STATE HIGHWAY 105 / JACKSON CREEK PKWY. - PHASE 2 CONSTRUCTION PLANS			
ROADWAY IMPROVEMENT PLANS			
STANDARD NOTES			
DESIGNED BY	PRA	SCALE	DATE 02-23-23
DRAWN BY	PRA	(H) 1"=VARIES	SHEET 2 OF 23
CHECKED BY	(V) 1"= N/A	JOB NO.	1.302.22

STATE HIGHWAY 105 / JACKSON CREEK PKWY. - PHASE 2 CONSTRUCTION PLANS			
ROADWAY IMPROVEMENT PLANS			
DEMOLITION PLAN			
DESIGNED BY	PRA	SCALE	DATE 02-23-23
DRAWN BY	PRA	(H) 1" = 60'	SHEET 4 OF 23
CHECKED BY	(V) 1" = N/A	JOB NO.	1302.22

STATE HIGHWAY 105 / JACKSON CREEK PKWY. - PHASE 2 CONSTRUCTION PLANS  
ROADWAY IMPROVEMENT PLANS  
HIGHWAY 105 PLAN & PROFILE

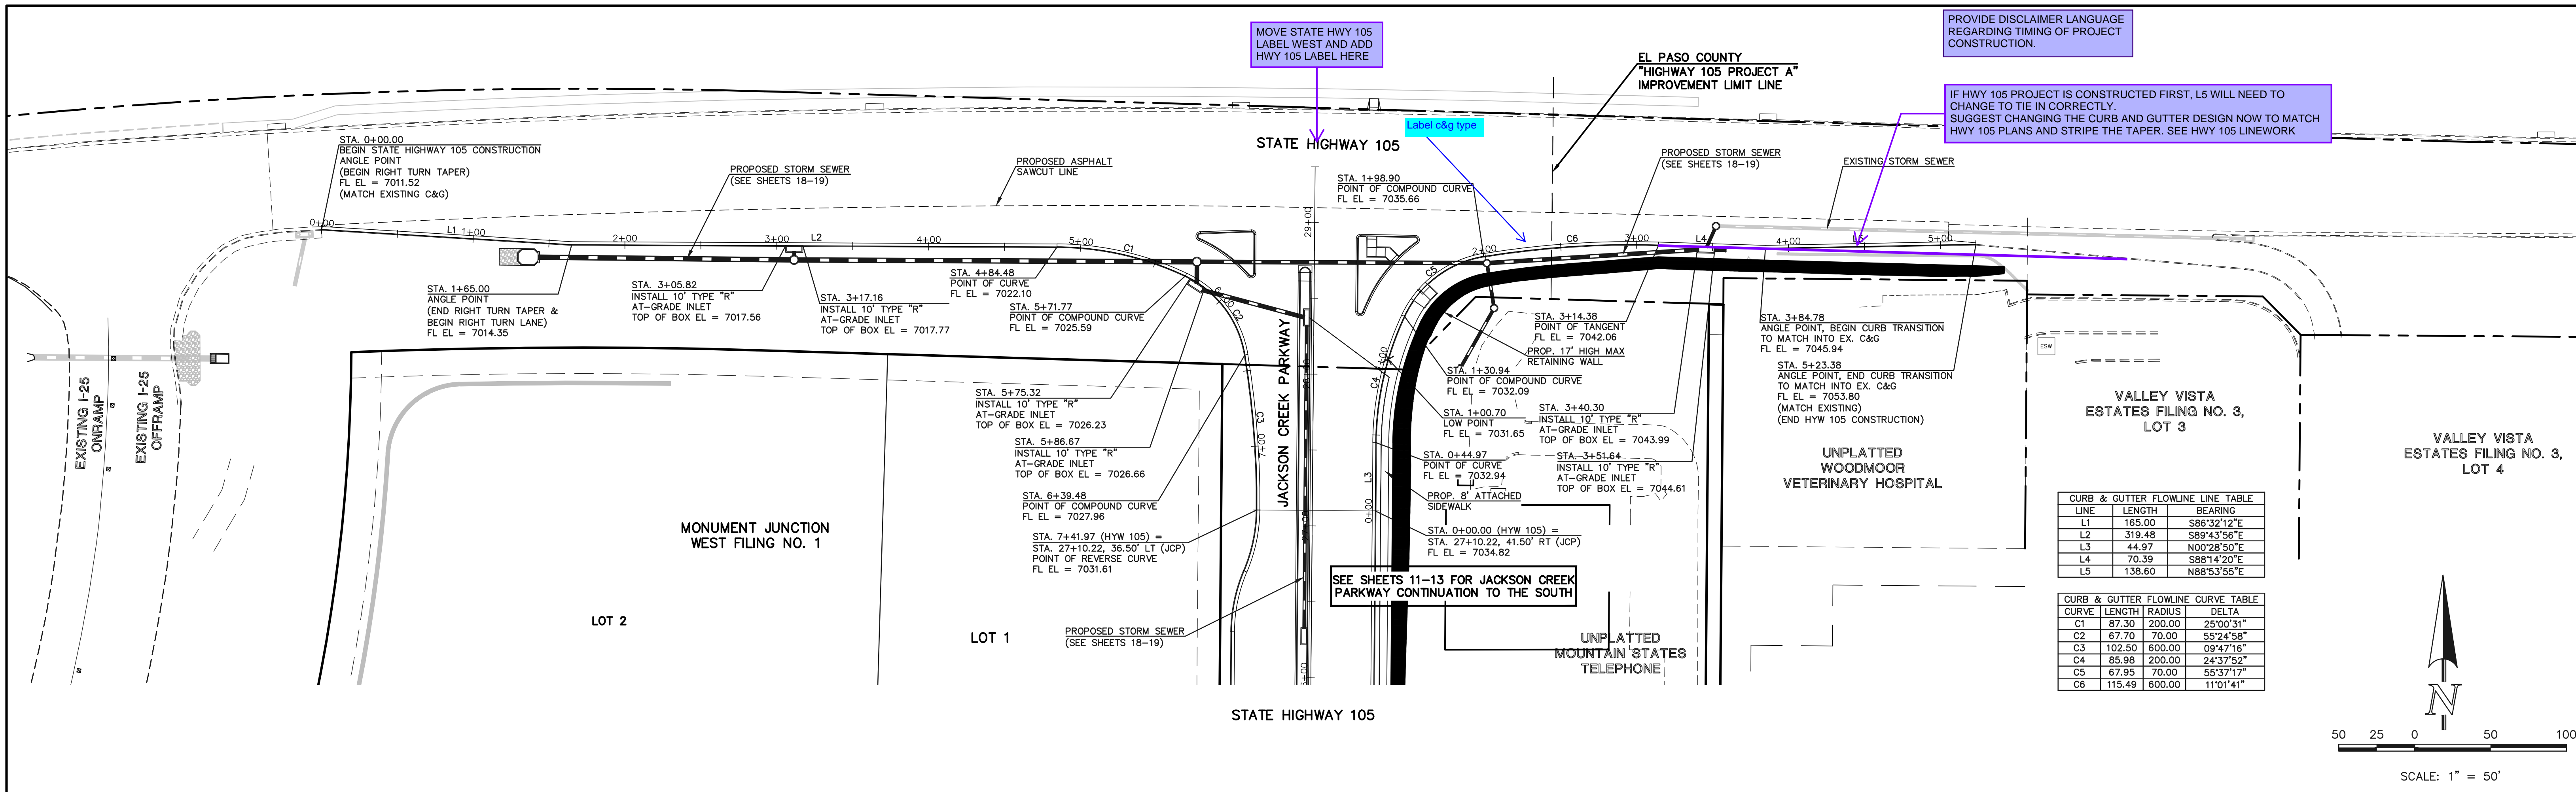
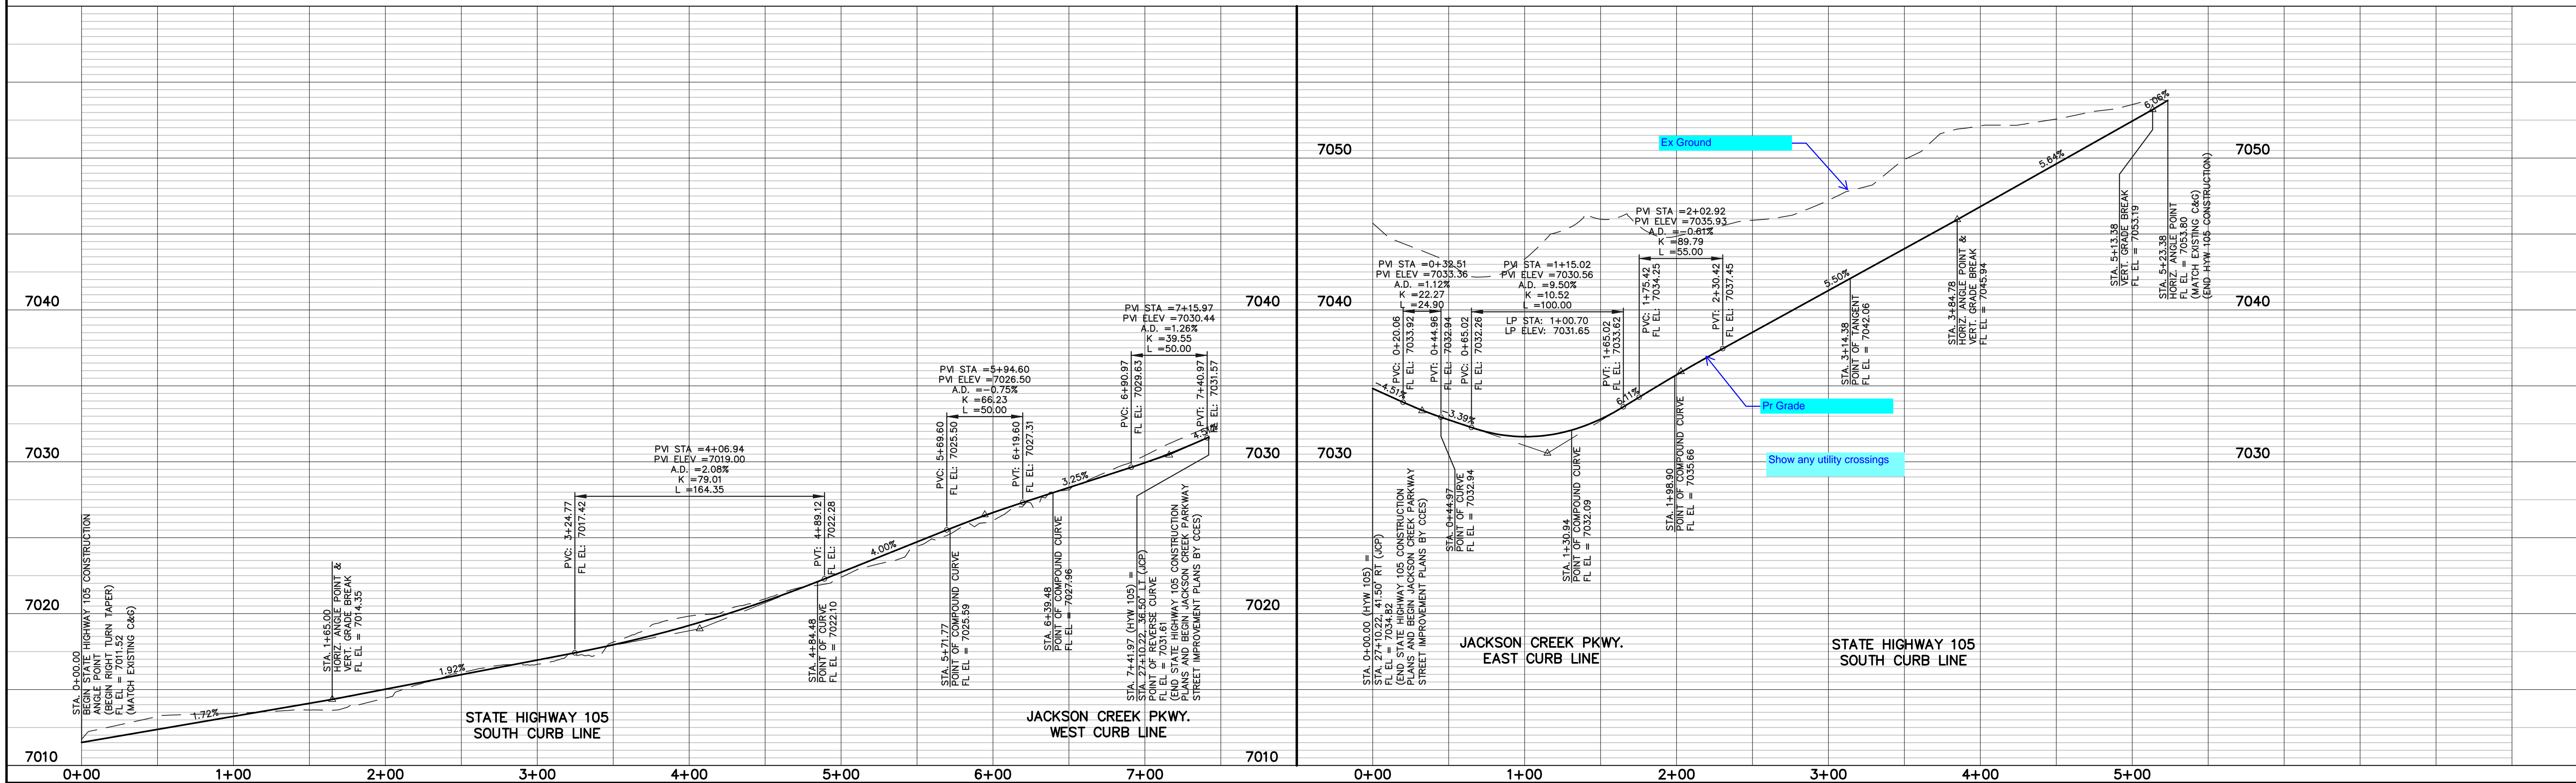
PROVIDE DISCLAIMER LANGUAGE REGARDING TIMING OF PROJECT CONSTRUCTION.

IF HWY 105 PROJECT IS CONSTRUCTED FIRST, L5 WILL NEED TO CHANGE TO TIE IN CORRECTLY. SUGGEST CHANGING THE CURB AND GUTTER DESIGN NOW TO MATCH HWY 105 PLANS AND STRIPE THE TAPER. SEE HWY 105 LINWORK

STATE HIGHWAY 105 / JACKSON CREEK PKWY. - PHASE 2 CONSTRUCTION PLANS  
ROADWAY IMPROVEMENT PLANS  
JACKSON CREEK PKWY. PLAN & PROFILE

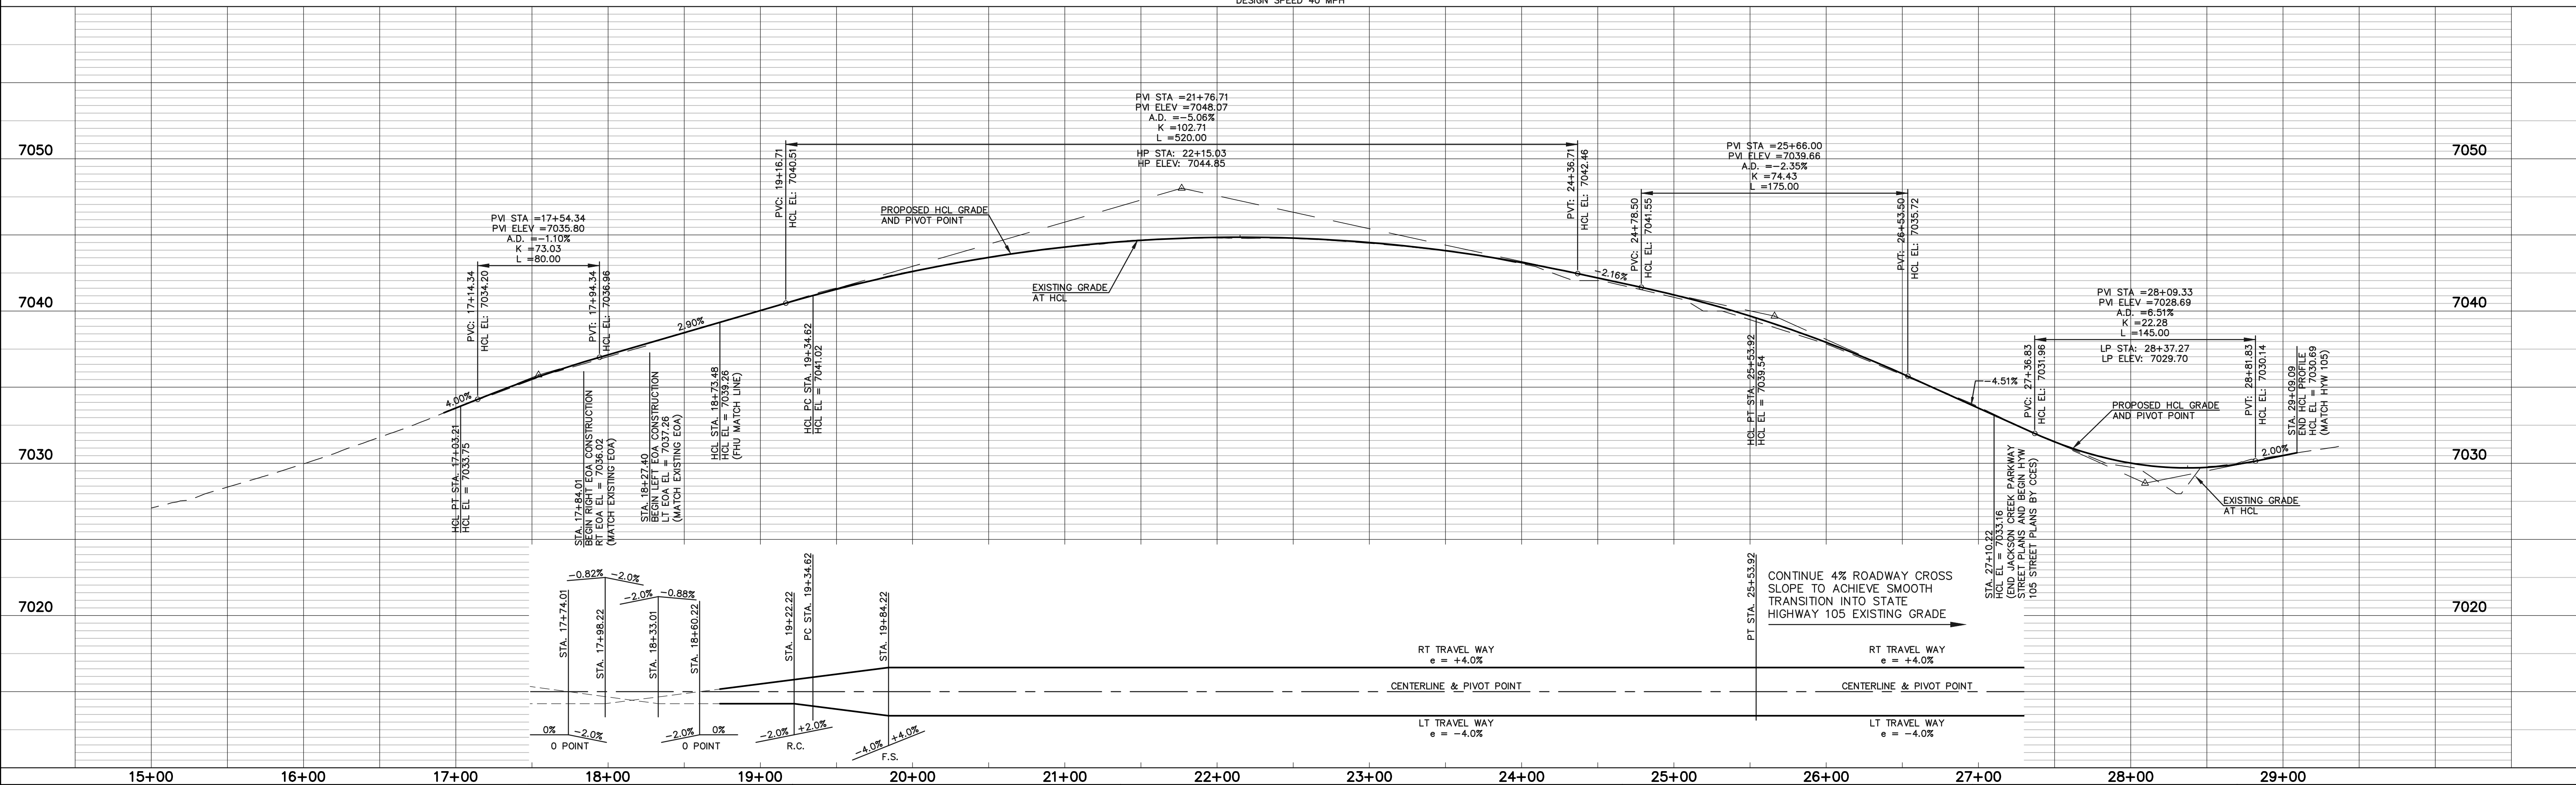
DELETE 'STATE' HERE. CDOT'S STATE HWY 105 IS ON WEST SIDE OF JCP.

STATE HIGHWAY 105 / JACKSON CREEK PKWY. - PHASE 2 CONSTRUCTION PLANS			
ROADWAY IMPROVEMENT PLANS			
INTERSECTION RAISED MEDIAN PLAN			
DESIGNED BY	PRA	SCALE	DATE 02-23-23
DRAWN BY	PRA	(H) 1" = 50'	SHEET 13 OF 23
CHECKED BY	(V) 1" = 5'	JOB NO.	1302.22

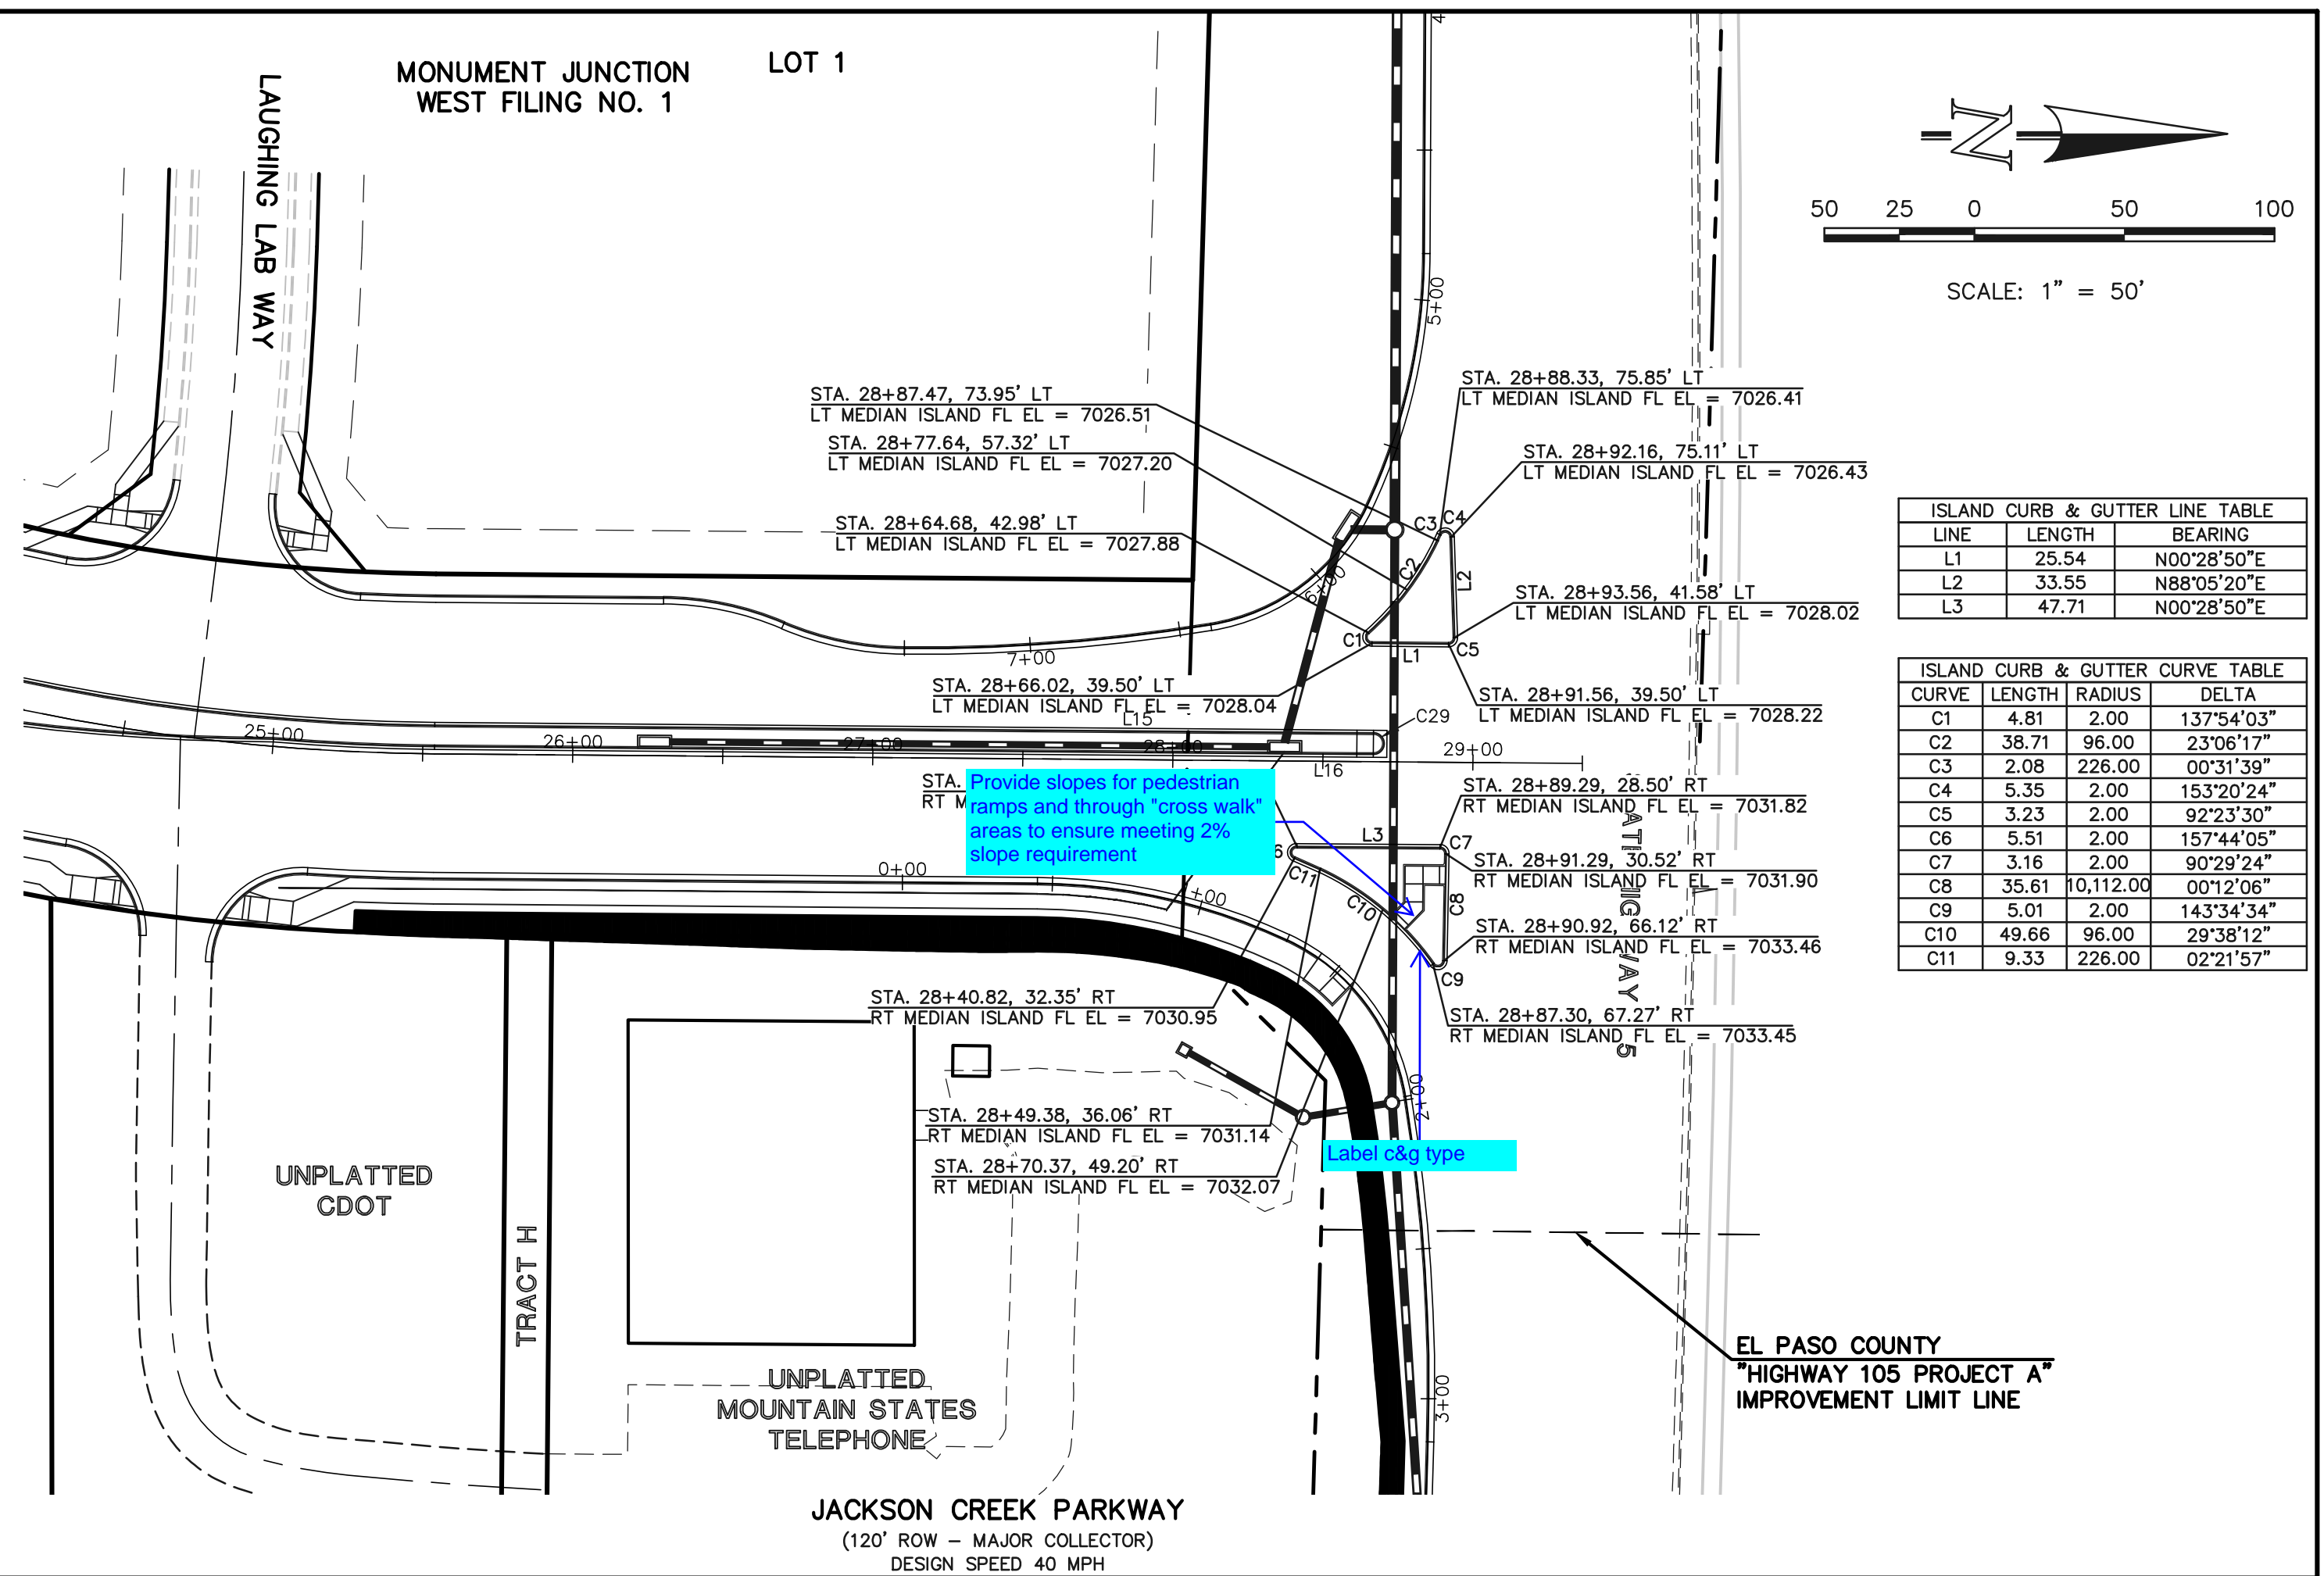
Provide slopes for pedestrian ramps and through "cross walk" areas to ensure meeting 2% slope requirement
